HISTORIC AND DESIGN REVIEW COMMISSION

HDRC CASE NO: 2018-190
ADDRESS: 1910 E HOUSTON ST
430 N MONUMENTAL
129 FLORENCE ALLEY
LEGAL DESCRIPTION: NCB 1372 BLK 4 LOT 1&2
NCB 1372 BLK 4 LOT 3 & N 20 FT OF 4
NCB 1372 BLK 4 LOT E 75 OF S 20 OF 4, E 75 OF 5 OR 4B & 5B
ZONING: C-2, RM-4 H
CITY COUNCIL DIST.: 2
DISTRICT: Dignowity Hill Historic District
APPLICANT: L. Shannon O'Malley
OWNER: L. Shannon O'Malley
TYPE OF WORK: Construction of four, two story, single family residential structures
APPLICATION RECEIVED: April 13, 2018
60-DAY REVIEW: June 12, 2018
REQUEST:

The applicant is requesting conceptual approval to construct four, two story, single-family residential structures on the vacant lots bounded by N Monumental, E Houston and Florence Alley. The lots included in this request are numbered 40, 41, 47 and 48.

Lot - 48

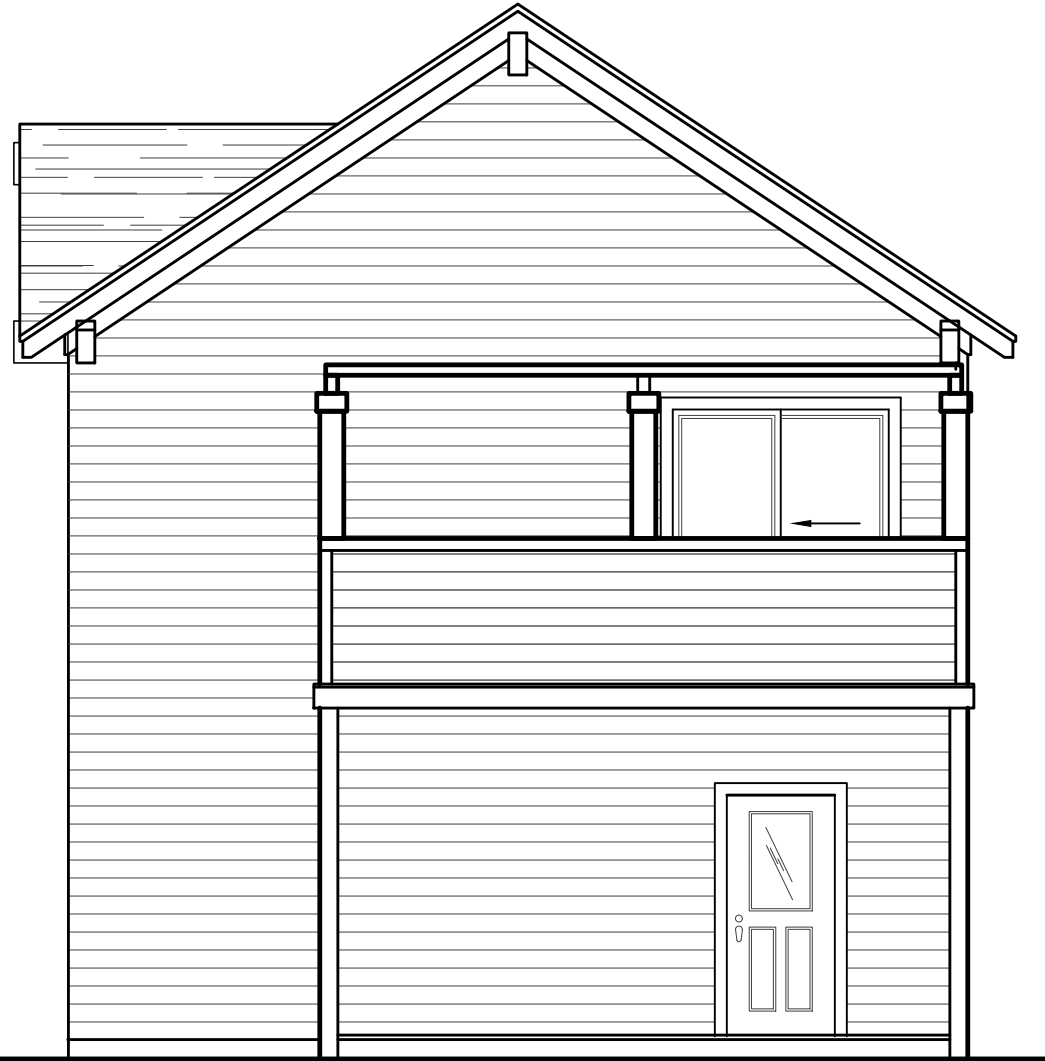
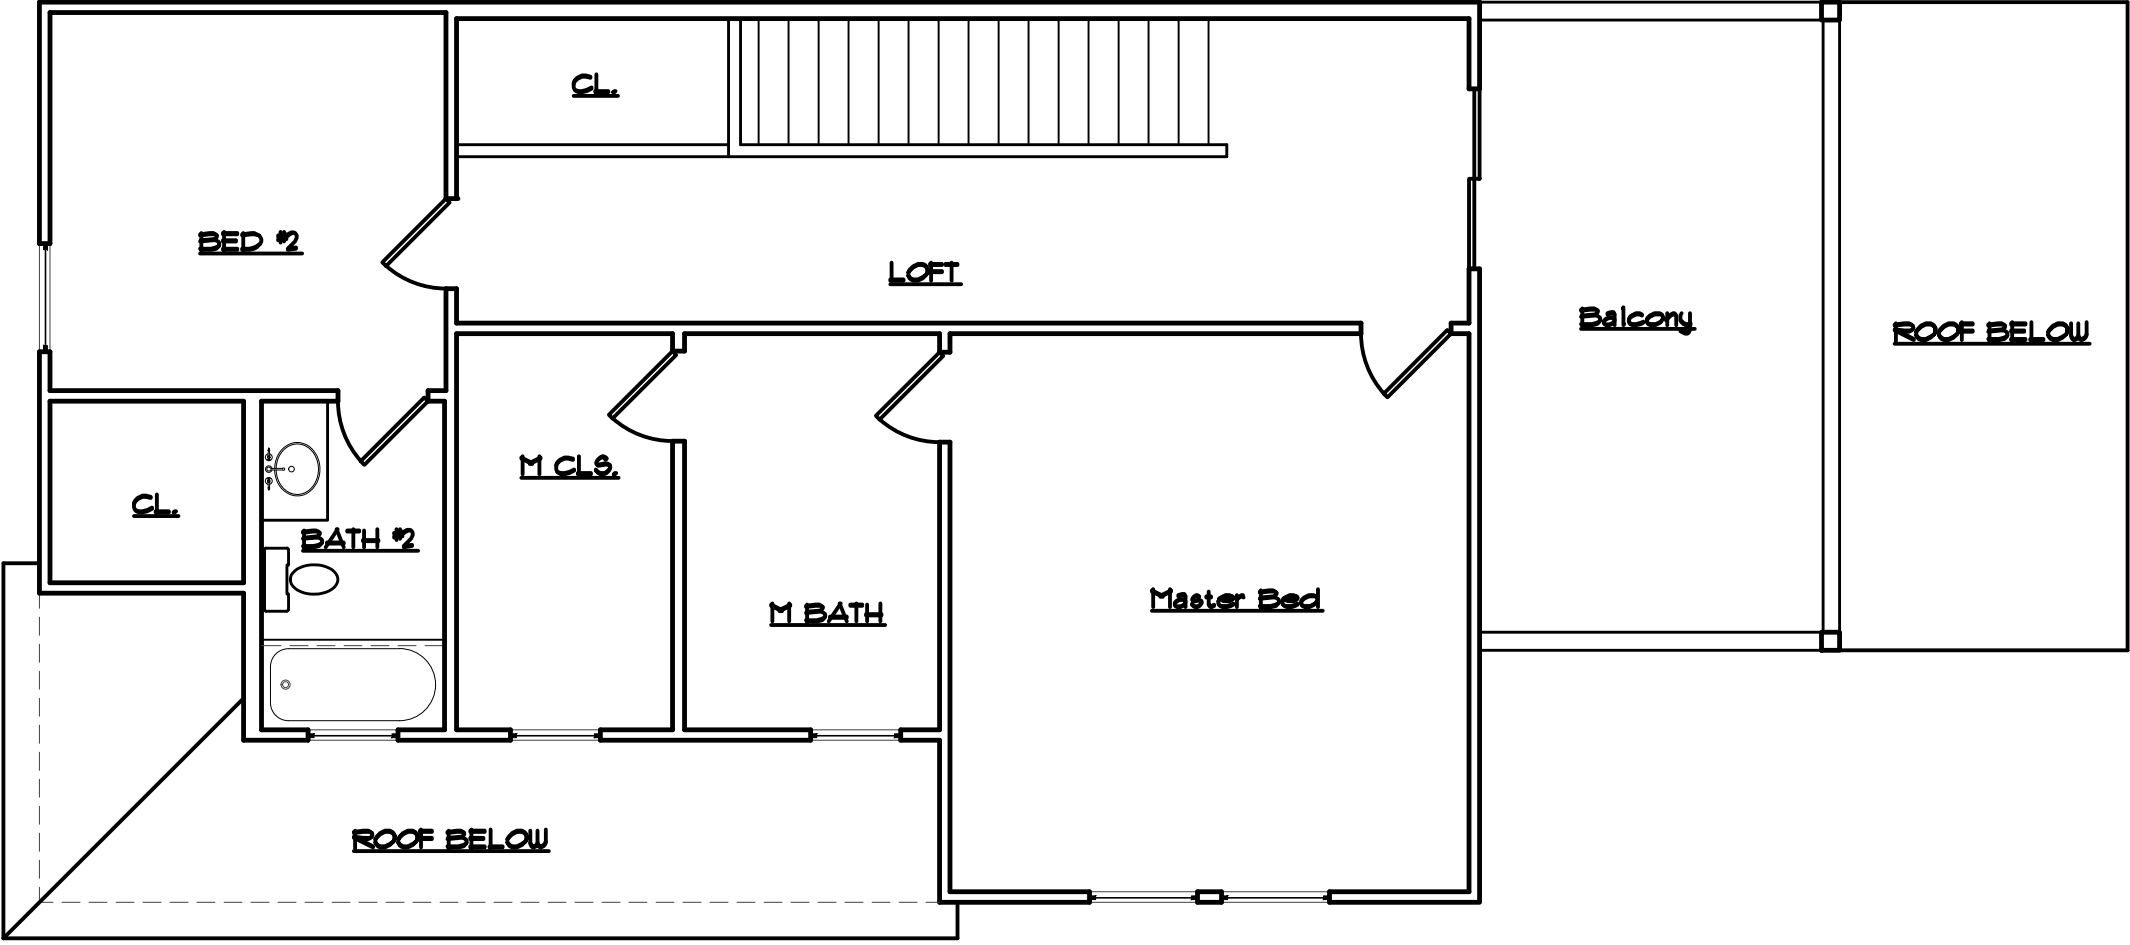
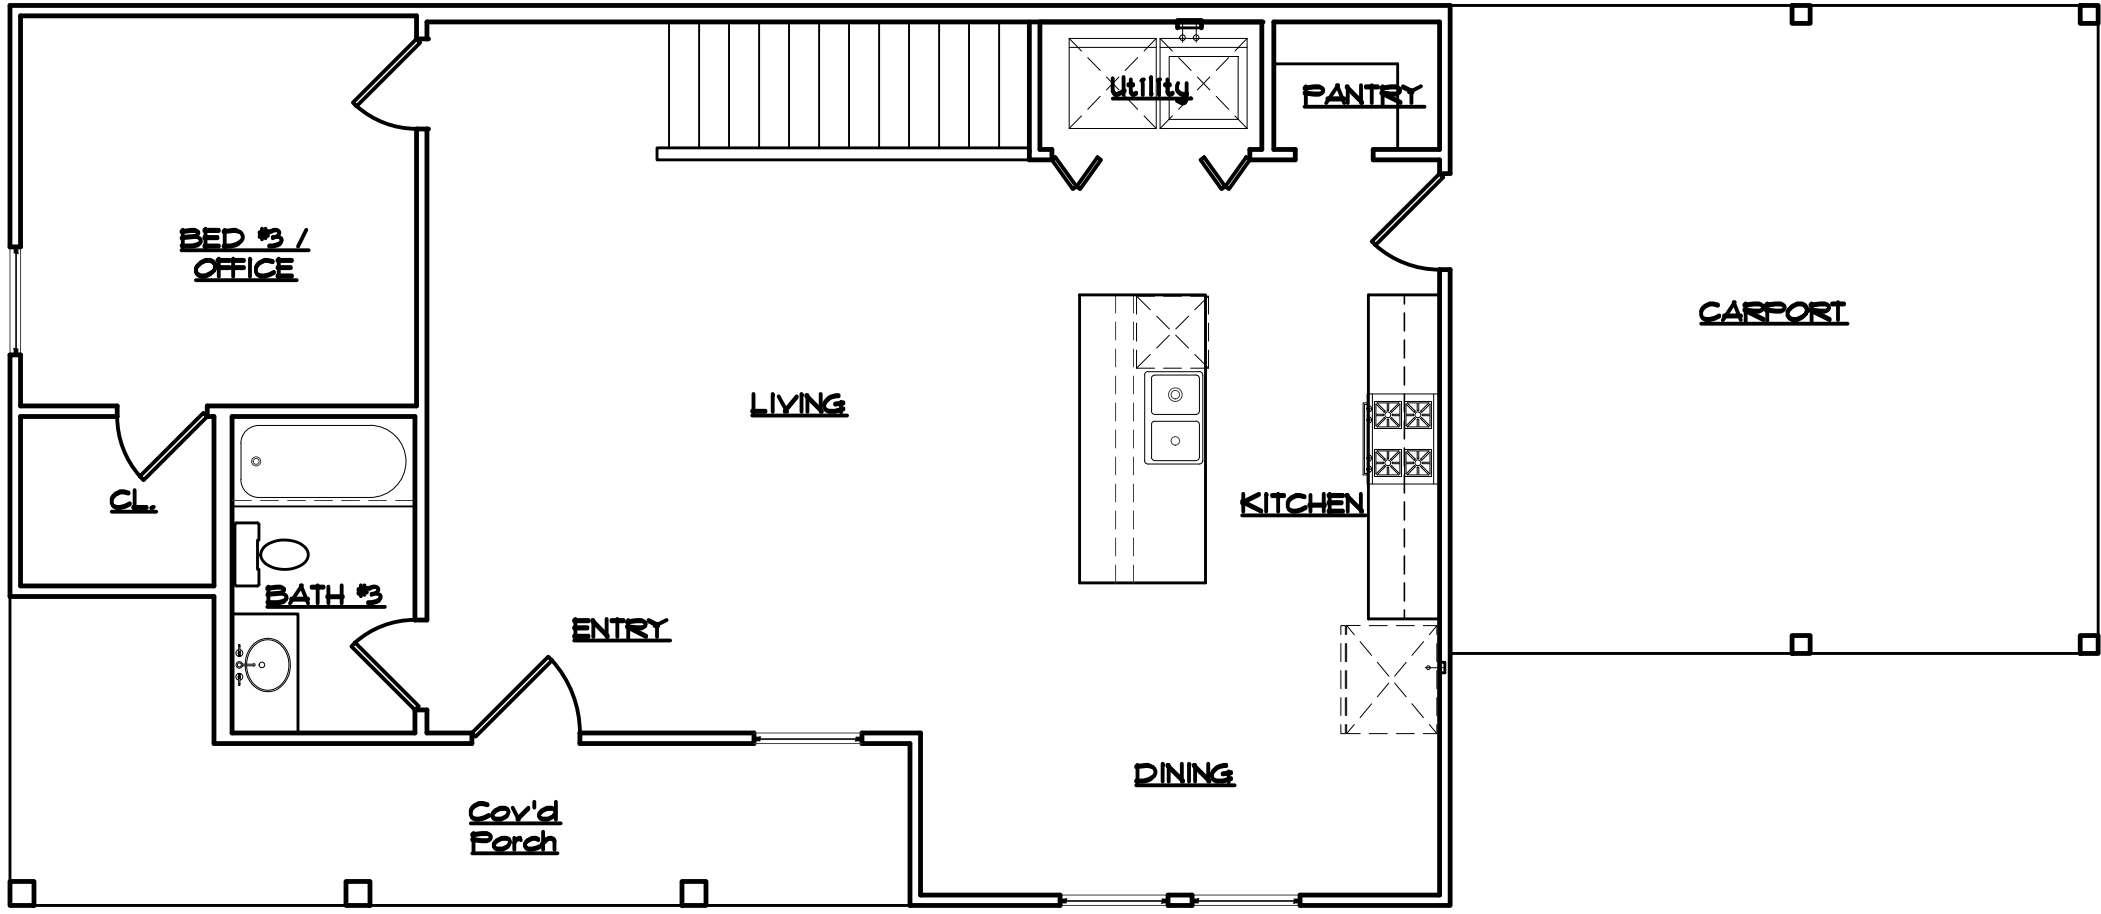
- o. **ARCHITECTURAL DETAILS**– The proposed new construction on lot 48 should feature a transom window above the proposed front door, sash windows and windows or doors at the terminus of the proposed wrap around porch. The proposed new construction on lot 47 should feature a smaller window adjacent to the front door, or a centered door with side lites and a transom window. All transom windows should feature divided lites.

- vii. That the proposed new construction on lot 48 feature a transom window above the proposed front door and a window or door on both levels one and two where the wraparound porch terminates. The proposed new construction on lot 47 should feature a smaller window adjacent to the front door, or a centered door with side lites and a transom window. All transom windows should feature divided lites.
